SEWAGE DISPOSAL SYSTEM

HOWARD COUNTY HEALTH DEPARTMENT

SUBDIVISION Glenelg Manor LOT 24D ROAD 12857 Folly Quarter Road

SITE DEVELOPMENT PLAN
12857 Folly Quarter Road
Parcel 24 D

Approved Septic System Plan
 Howard County Health Department

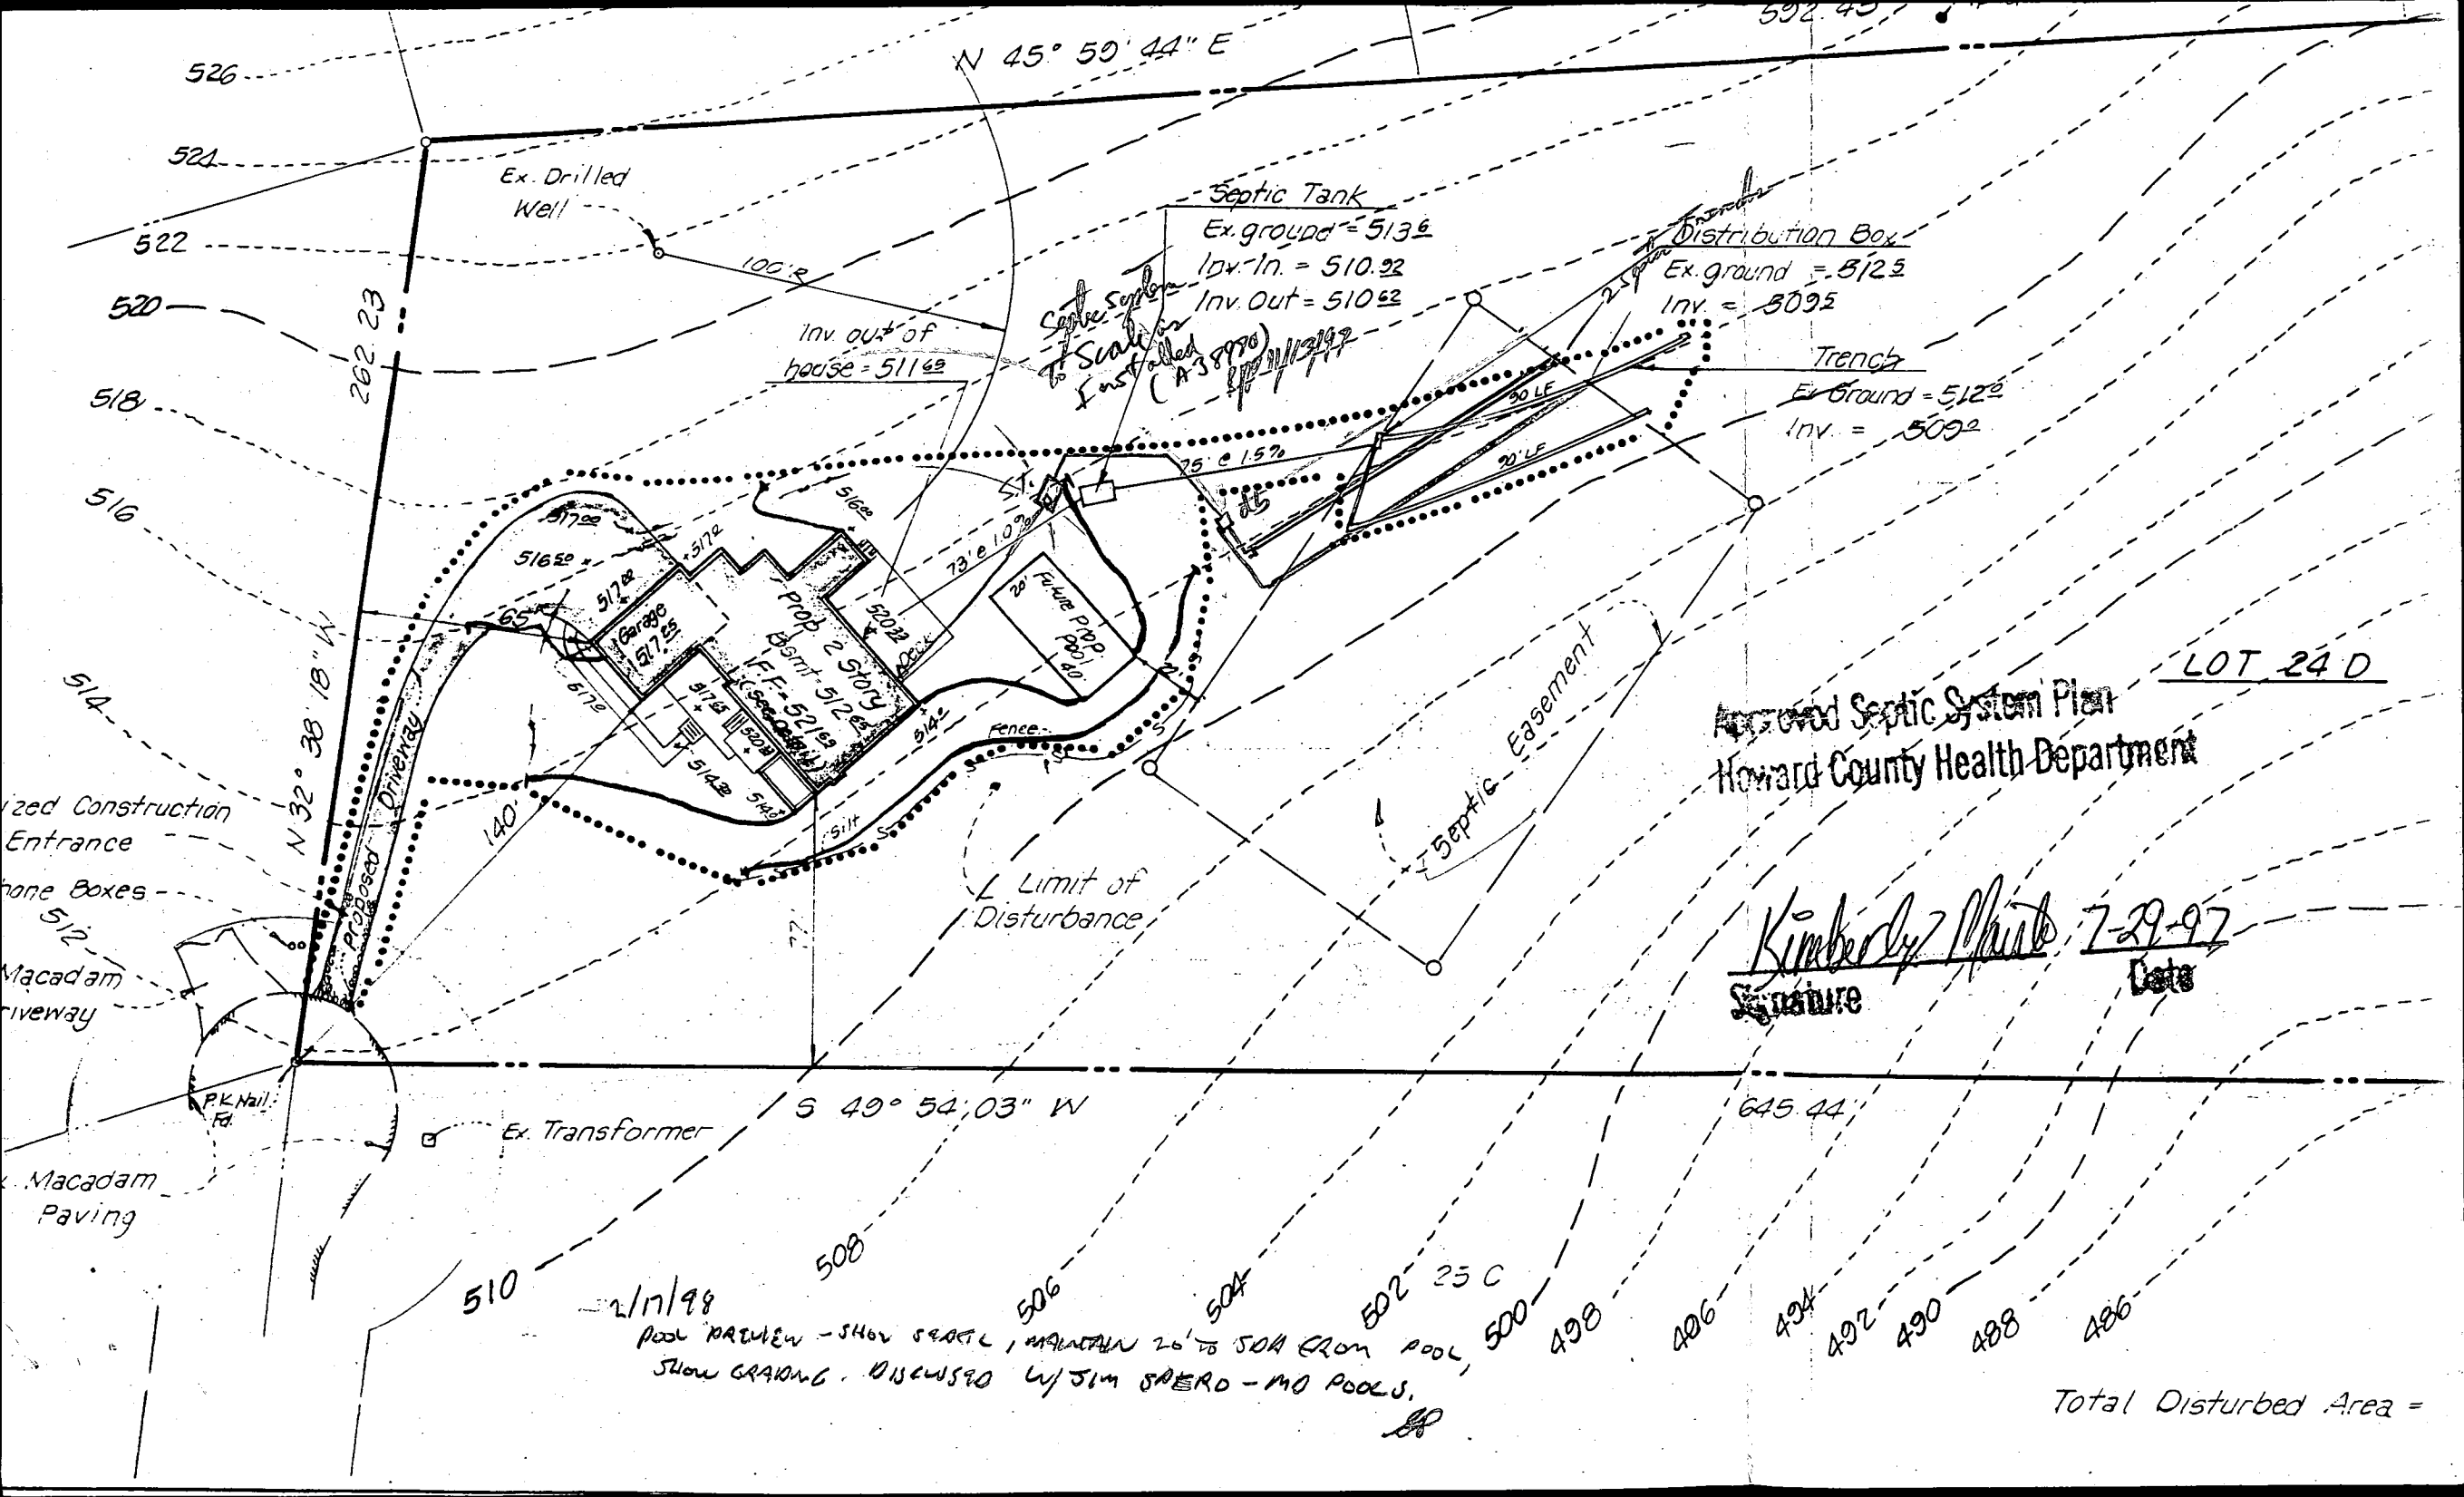
POOL REVIEW - SHOW SEATTLE, MAINTAIN 20' TO 50' FROM POOL, SHOW GRADING. DISCUSSED W/ JIM SPERD - NO POOLS.

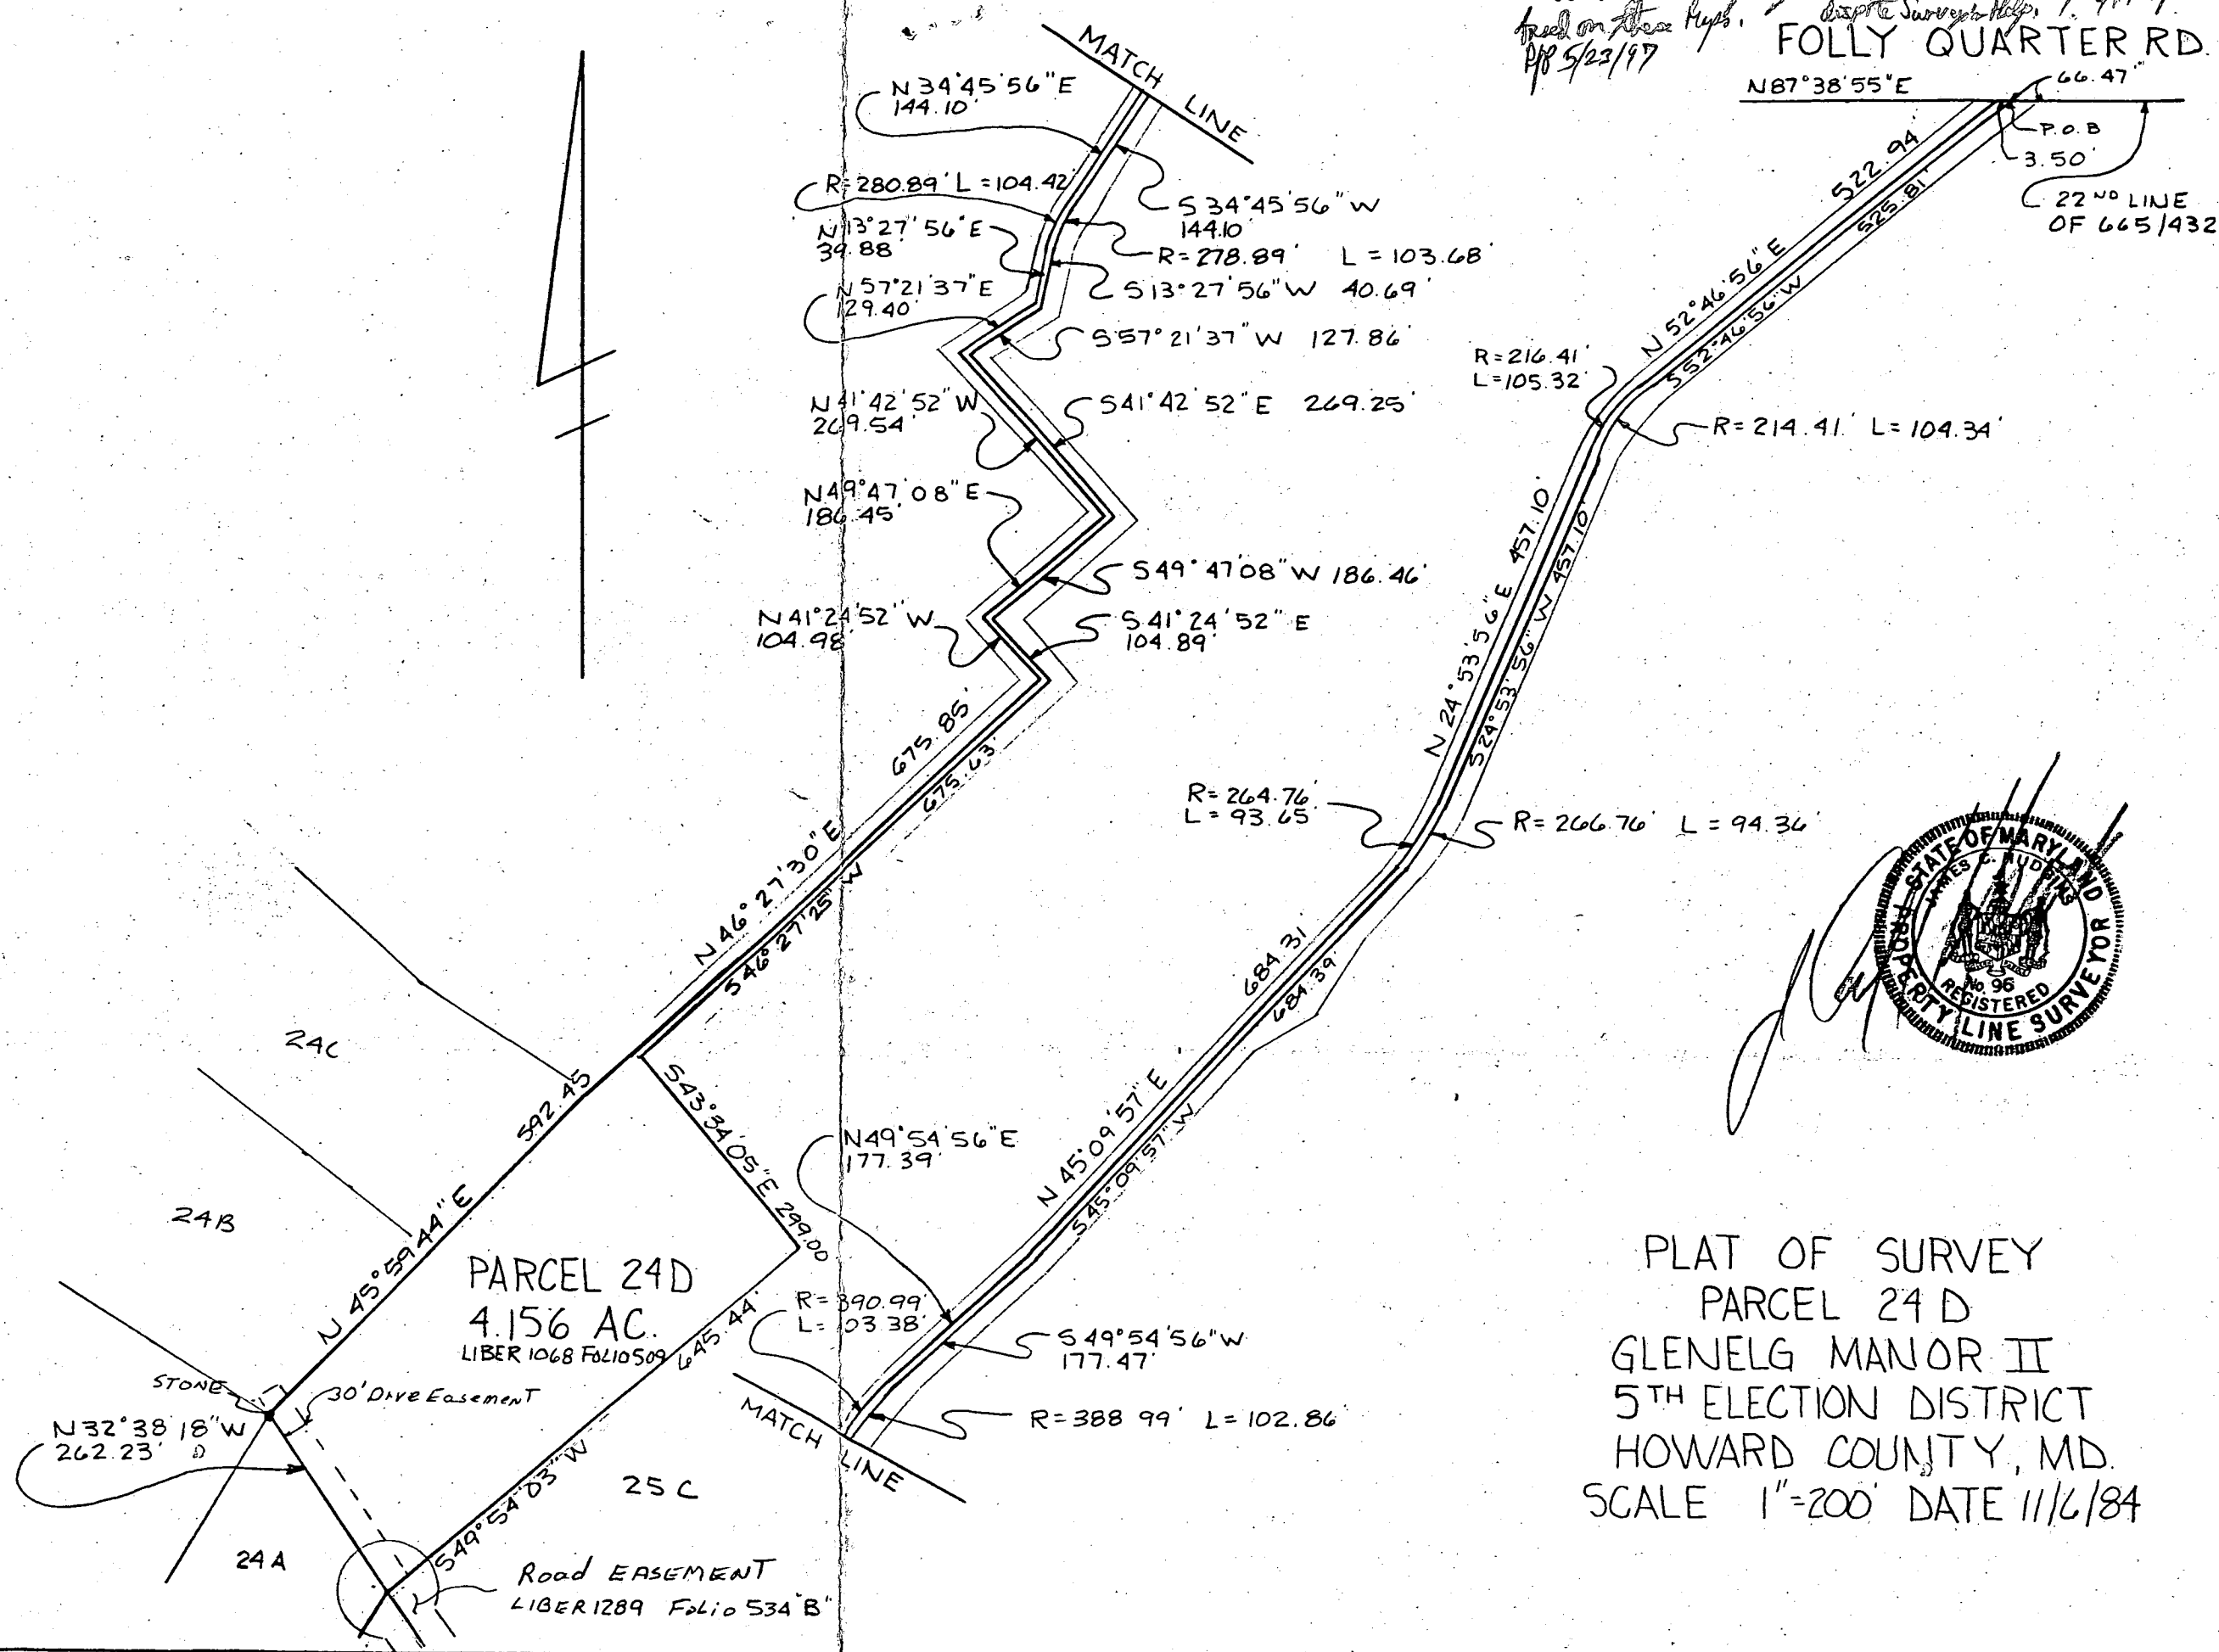
I WISH TO AMEND BUILDING PERMIT
NUMBER B00110016 FOR 12857
FOLLY QUARTER RD PER W.O.G. HEALTH
DEPTS REQUEST TO RELOCATE POOL.
THE HEALTH DEPT. ALLOWED US
TO MOVE WITHIN 14 FT OF THE
SHOWN RESERVE AREA. THE HEALTH
DEPT. HAS A COPY OF THE REVISION
PLAN.

3/5/98 proposed revision to pool location ok as
shown. [Signature]

SITE PLAN
1"=50'
PARCEL 24D

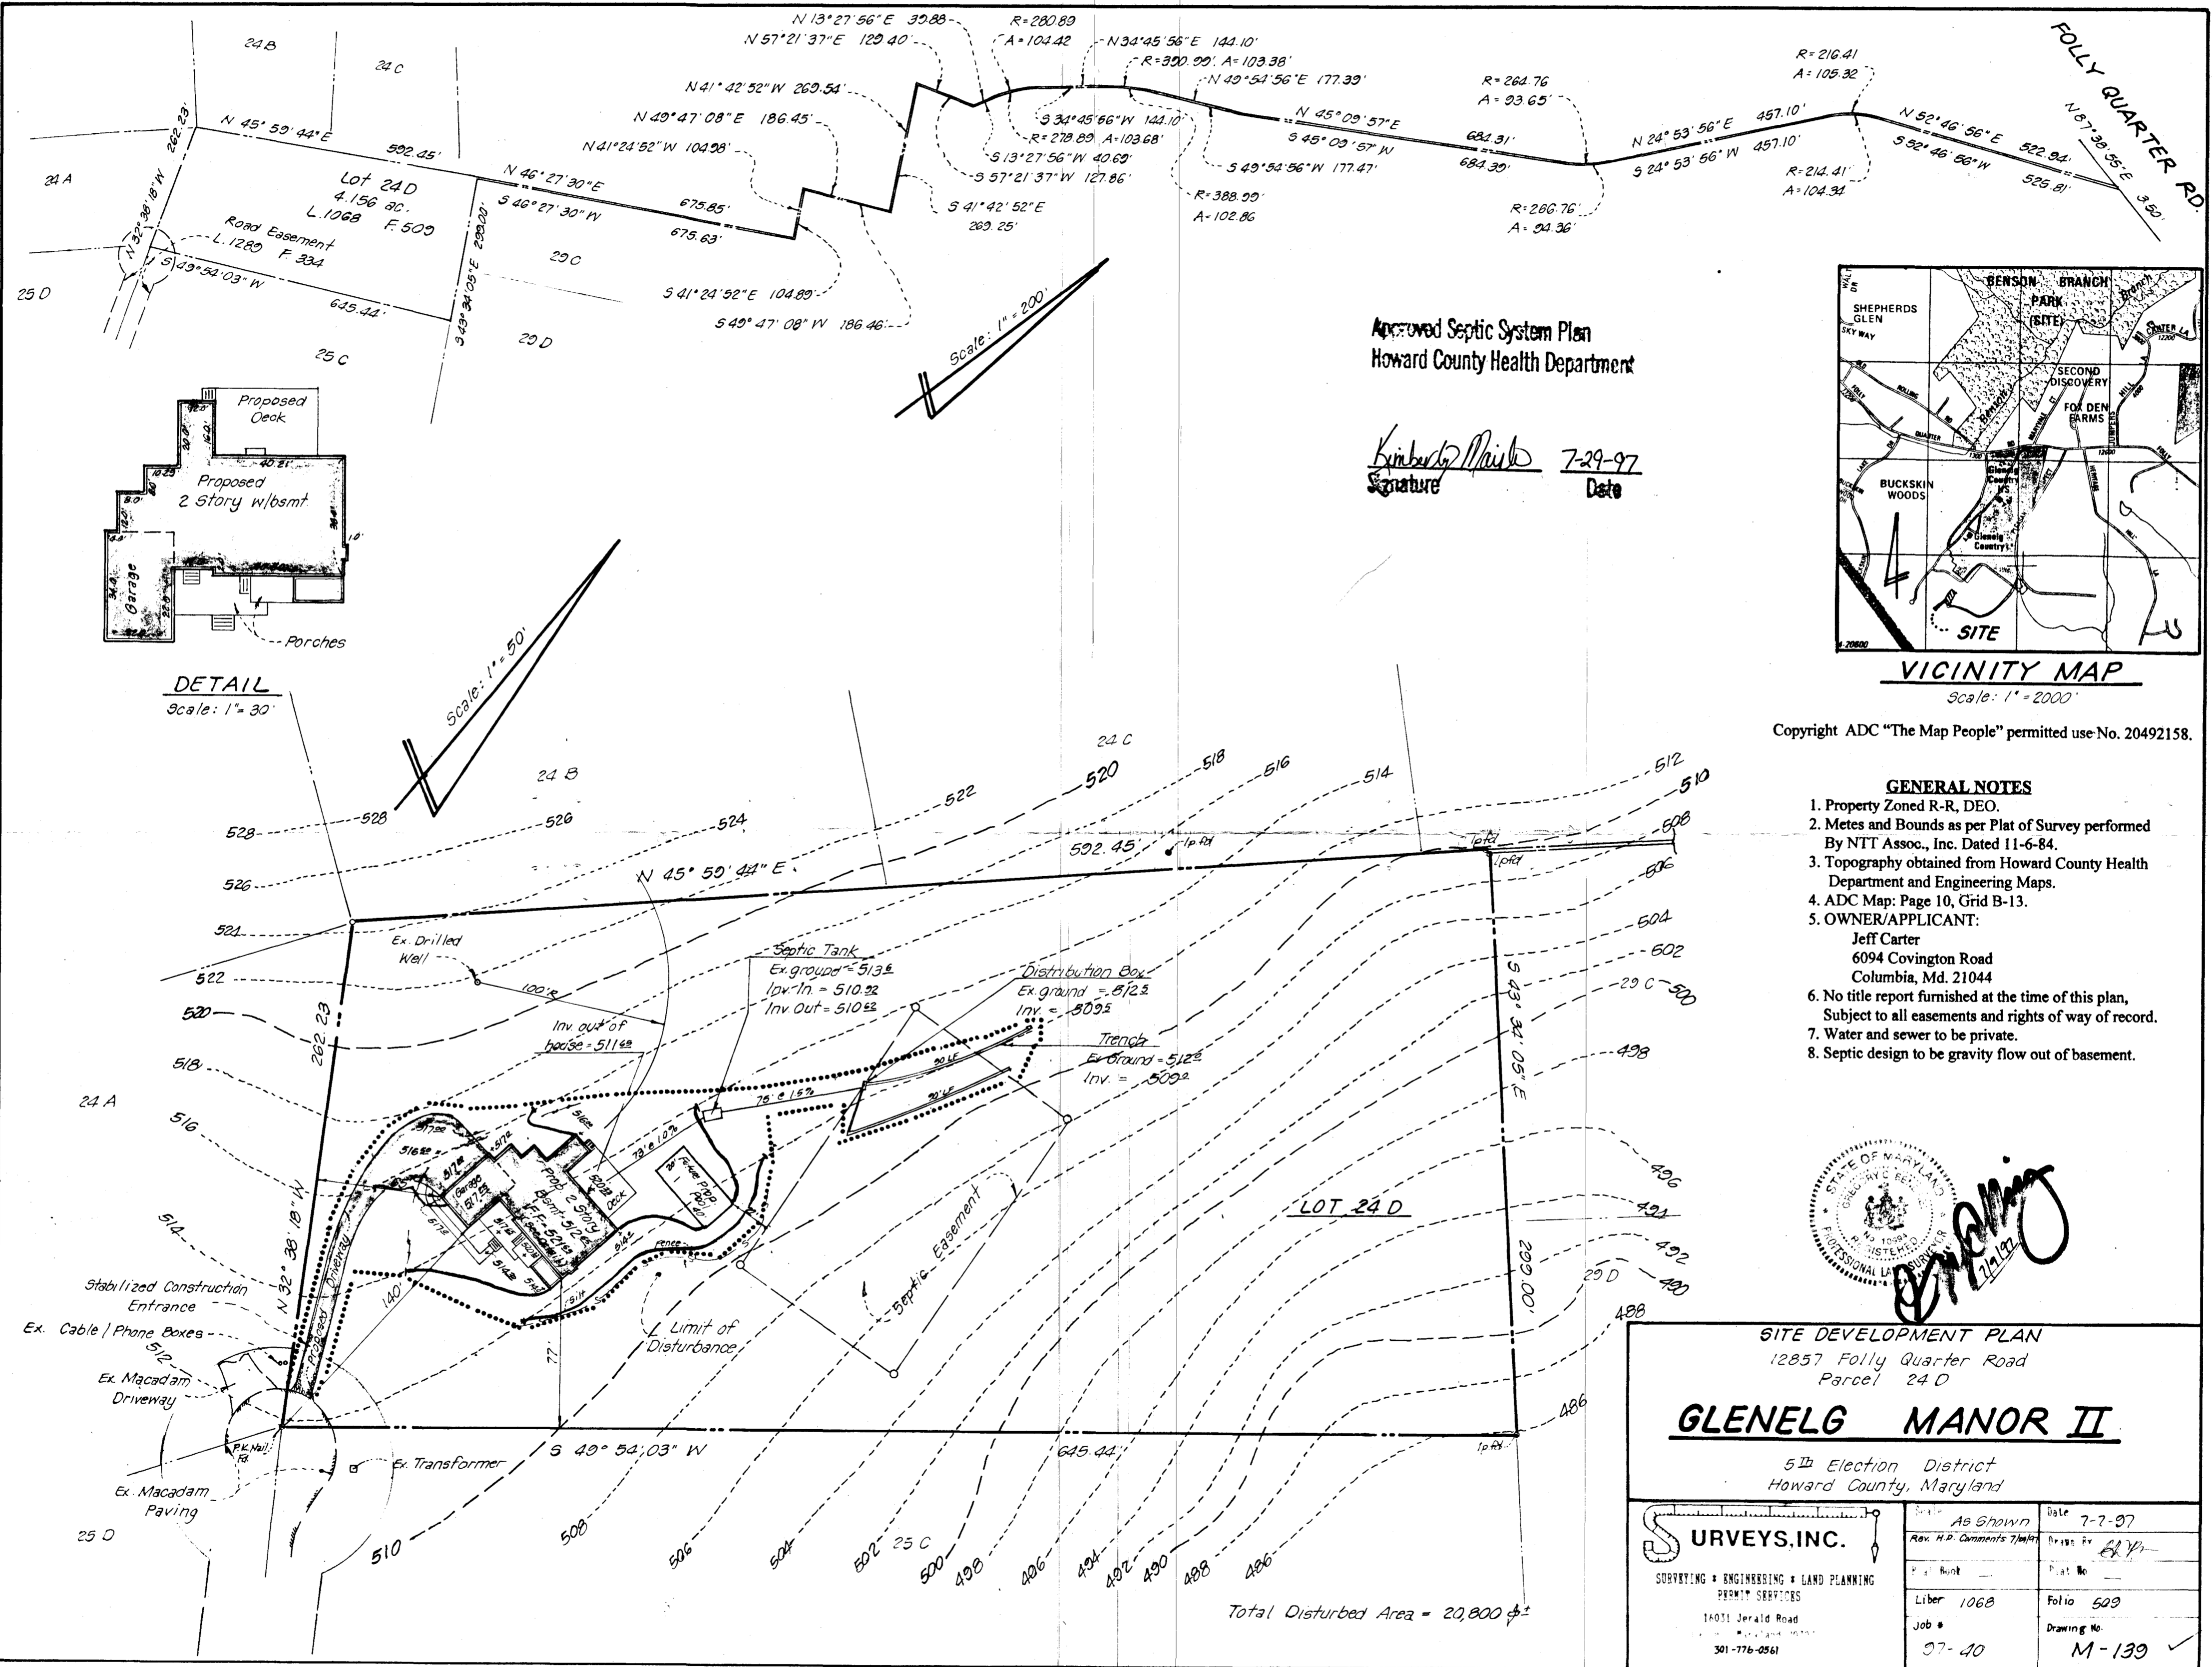
198
need revision
of location of
drum.
Donna SDE

NOTE: POOL LOCATION
APPROVED 2/23/98
PER DONNA SDE,
HOWARD COUNTY DEPT.
OF ENVIRONMENTAL
HEALTH. POOL SHALL NOT
IMPACT ON SEPTIC OR
WELL SYSTEMS
